PIC24FJ256GB210 Family Silicon Errata and Data Sheet Clarification

Data Sheet Clarifications

The following typographic corrections and clarifications are to be noted for the latest version of the device data sheet (DS39975A):

FIGURE 2-3 FREQUENCY vs. ESR PERFORMANCE FOR SUGGESTED VCAP

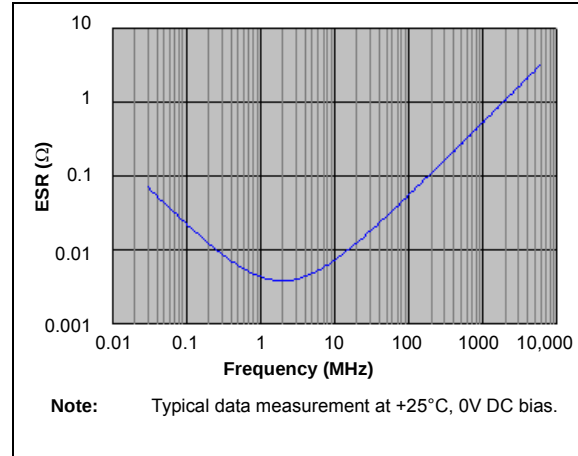
Section 2.4 “Voltage Regulator Pins (ENVREG and VCAP)” has been replaced with a new and more detailed section. The entire text follows:

When the regulator is enabled, a low-ESR ($< 5\Omega$) capacitor is required on the VCAP pin to stabilize the voltage regulator output voltage. The VCAP pin must not be connected to VDD and must use a capacitor of 10 μF connected to ground. The type can be ceramic or tantalum. Suitable examples of capacitors are shown in [Table 2-1](#). Capacitors with equivalent specifications can be used.

Designers may use [Figure 2-3](#) to evaluate ESR equivalence of candidate devices.

The placement of this capacitor should be close to VCAP. It is recommended that the trace length not exceed 0.25 inch (6 mm). Refer to **Section 29.0 “Electrical Characteristics”** for additional information.

FIGURE 2-4 DC BIAS VOLTAGE vs. CAPACITANCE CHARACTERISTICS

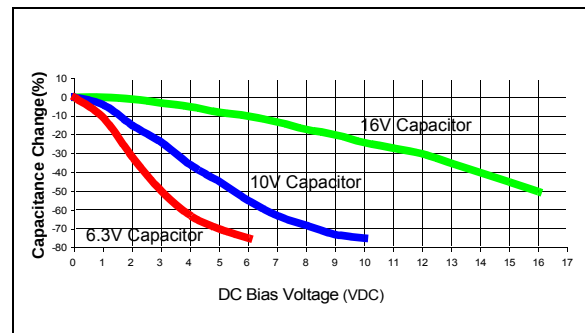
In addition to temperature tolerance, the effective capacitance of large value ceramic capacitors can vary substantially, based on the amount of DC voltage applied to the capacitor. This effect can be very significant, but is often overlooked or is not always documented.

A typical DC bias voltage vs. capacitance graph for 16V, 10V and 6.3V rated capacitors is shown in Figure 2-4.

When selecting a ceramic capacitor to be used with the internal voltage regulator, it is suggested to select a high-voltage rating, so that the operating voltage is a small percentage of the maximum rated capacitor voltage. For example, choose a ceramic capacitor rated at 16V for the 1.8V core voltage. Suggested capacitors are shown in Table 2-1.

FIGURE 29-1: PIC24FJ256GB210 FAMILY VOLTAGE-FREQUENCY GRAPH (INDUSTRIAL)

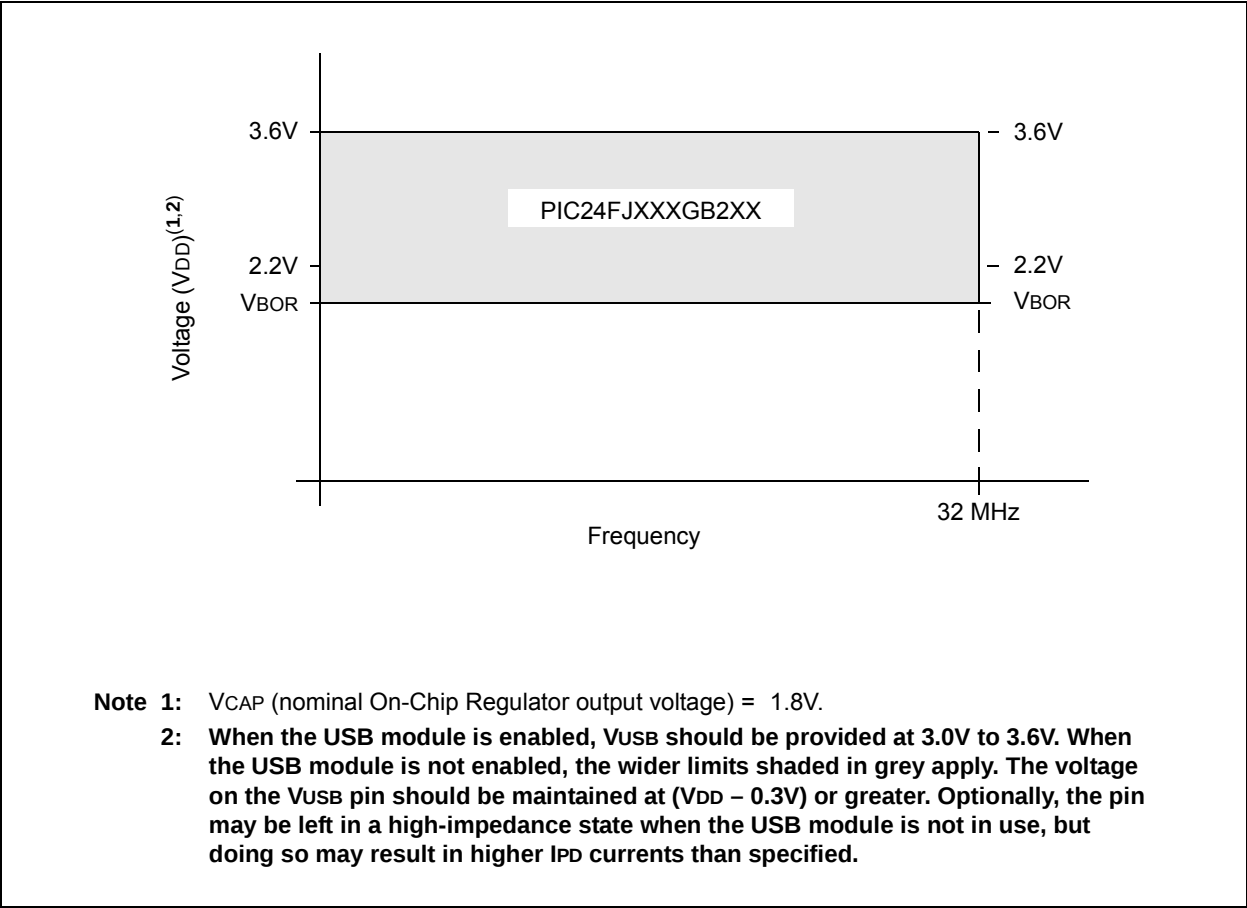
Figure 29-1 (“PIC24FJ256GB210 Family Voltage-Frequency Graph”) is amended by adding an additional footnote. The updated figure is shown below (changes in **bold**; bold in original removed for clarity).
